UNITED STATES PATENT AND TRADEMARK OFFICE

APPLICATION NO.	FILING DATE	FIRST NAMED INVENTOR	ATTORNEY DOCKET NO.	CONFIRMATION NO.
10/068,062	02/05/2002	Ming-Hui Chou	P-3641.177	8329

Office Action Summary

DETAILED ACTION

Poole [U.S. Patent No. 2,273,660] Figure 3

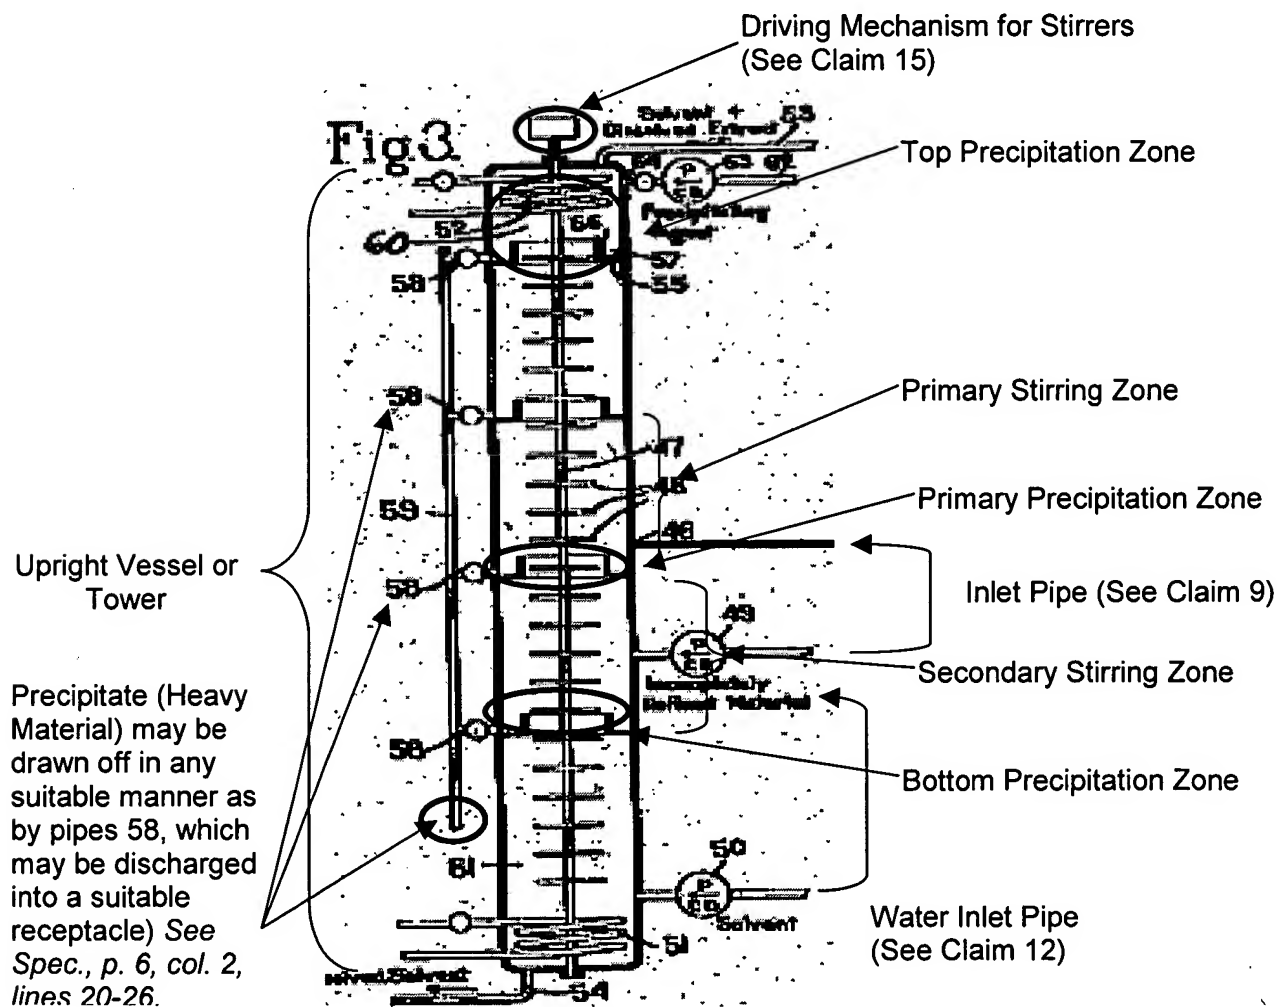
Regarding claim 1, Poole teaches a separation device, comprising: a tank (See Figure 3; upright vessel or tower 46) with multiple stirring zones (See Figure 3; series of mixing arms or paddles 48), multiple precipitation zones alternately arranged with the stirring zones (See Figure 3; See Specification, p. 6, col. 2, lines 8-16 – one or more annular catch basins 57 alternately arranged with the series of mixing arms or paddles 48), an outlet in a top portion of the tank (See Figure 3; discharge pipe 53), an inlet defined adjacent to the outlet (See Figure 3; inlet pipe 62), and a water inlet defined in the bottom portion of the tank (See Figure 3; solvent inlet pipe 50); and a collecting tank engaged with and communicating with the tank (See Figure 3; See Specification, p. 6, col. 2, lines 20-23 – this heavier material may be drawn off in any suitable manner as by pipes 58, which may be discharged into a suitable receptacle, e.g. a collecting tank for the precipitation), wherein each precipitation zone has an extraction pipe (pipes 58) and each stirring zone has stirring blades (mixing arms or paddles 48).

Regarding claim 4, Poole teaches the separation device as identified in claim 1 above, wherein the separation device comprises multiple alternating stirring and precipitation zones (See Figure 3 below; See Specification, p. 6, col. 1, line 59 to col. 2, line 16 – series of mixing arms or paddles 48 and one or more annular catch basins provided intermediate of the length of the tower). Figure 3 discloses one embodiment with four (4) stirring zones alternately arranged with four (4) precipitation zones. As described in the specification, Poole could comprise only two (2) stirring zones alternately arranged with three (3) precipitation zones. Thus, Poole further teaches the separation device as claimed in claim 1, wherein the tank (upright vessel or tower

46) is sequentially divided into a top precipitation zone, a primary stirring zone, a primary precipitation zone, a secondary stirring zone, and a bottom precipitation zone (See labeled Figure 3 below).

Regarding claim 3, Poole teaches the separation device as identified in claim 1 above in paragraph 4 and in claim 2 as aforementioned, wherein the separation device comprises multiple alternating stirring and precipitation zones (See Figure 3; See Specification, p. 6, col. 1, line 59 to col. 2, line 16 – series of mixing arms or paddles 48 and one or more annular catch basins provided intermediate of the length of the tower. Figure 3 discloses an embodiment with four (4) stirring zones alternately arranged with four (4) precipitation zones. As described in the specification, Poole could comprise only two (2) stirring zones alternately arranged with three (3) precipitation zones. Thus, Poole further teaches the separation device as claimed in claim 1, wherein the tank (upright vessel or tower 46) is sequentially divided into a top precipitation

zone, a primary stirring zone, a primary precipitation zone, a secondary stirring zone, and a bottom precipitation zone (See labeled Figure 3 above).

Regarding claim 8, Poole teaches the separation device as identified in claim 1 above in paragraph 4 and in claims 2 and 3 as aforementioned. Poole further teaches that the outlet is defined in the top precipitation zone at a side face of the tank (See Figure 3; discharge pipe 53 – See Specification, p. 6, col. 2, lines 2-6).

Regarding claim 9, Poole teaches the separation device as identified in claim 1 above in paragraph 4 and in claims 2 and 3 as aforementioned. Poole further teaches that the inlet is defined in the primary stirring zone (See Figure 3 above; feed pipe 49; See Specification, p. 6, col. 1, lines 63-66 – a feed pipe 49 preferably intermediate of its [the tank's] length through which the raw or incompletely refined substance [the water-soluble, non-water soluble composition] is introduced into the vessel, e.g. the feed pipe 49 would be positioned intermediate the length of the tower just above the primary precipitation zone in Figure 3 above, in the primary stirring zone).

Regarding claim 11, Poole teaches the separation device as identified in claim 1 above in paragraph 4 and in claims 2, 3, and 10 as aforementioned. Poole teaches that the extraction pipes associated with the primary precipitation zone are vertical with respect to the water level (See Figure 3; discharge pipes 58 and header 59 are vertical, e.g. parallel to the height of the tank).

Regarding claim 12, Poole teaches the separation device as identified in claim 1 above in paragraph 4 and in claims 2 and 3 as aforementioned. Poole teaches that the water inlet is defined in the secondary stirring zone (See Figure 3 above; pipe 50 – See Specification, p. 6, col. 1, lines 66-69 – preferably at a point beneath the feed of the raw material and at a suitable

Regarding claim 15, Poole teaches the separation device as identified in claim 1 above in paragraph 4 and in claims 2 and 3 as aforementioned. Poole teaches that the second stirring zone has second stirring blades provided therein (See Figure 3 above; second stirring zone with mixing arms or paddles 48) and the tank (upright vessel or tower 46) has a motor mounted on top thereof and an axle (rotating vertical shaft 47) extending from the motor to drive the first stirring blades and the second blades (See Figure 3 above; See Specification, p. 6, col. 1, lines 58-63).

Regarding claim 16, Poole teaches the separation device as identified in claim 1 above in paragraph 4 and in claims 2 and 3 as aforementioned. Poole teaches the separation device of claim 3, wherein a baffle is provided between the top precipitation zone and primary stirring zone, the primary stirring zone and the primary precipitation zone, the primary precipitation zone and the secondary stirring zone, and between the secondary stirring zone and the bottom precipitation zone (See Figure 3; See Specification, p. 6, col. 2, lines 10-16 – horizontal base 55 fitting tightly within and secured to the cylindrical wall of the vessel and an upwardly extending annular flange 56 located at a suitable distance from the wall of the vessel to provide catch basin 57), wherein each baffle (pair of horizontal bases 55 and extending annular flanges 56) is secured to an inner face of the tank and each baffle has a central opening aligned with each other (See Figure 3; central opening is the area located between the two horizontal bases 55 and extending annular flanges 56), and wherein an annular gap is defined between a distal edge of the baffle and the inner face of the tank (See Figure 3 above; See Specification, p. 6, col. 2, lines 10-16 – annular gap defined between the annular flange 56 and the inner wall of the tank, e.g. the area defined as the catch basin 57).
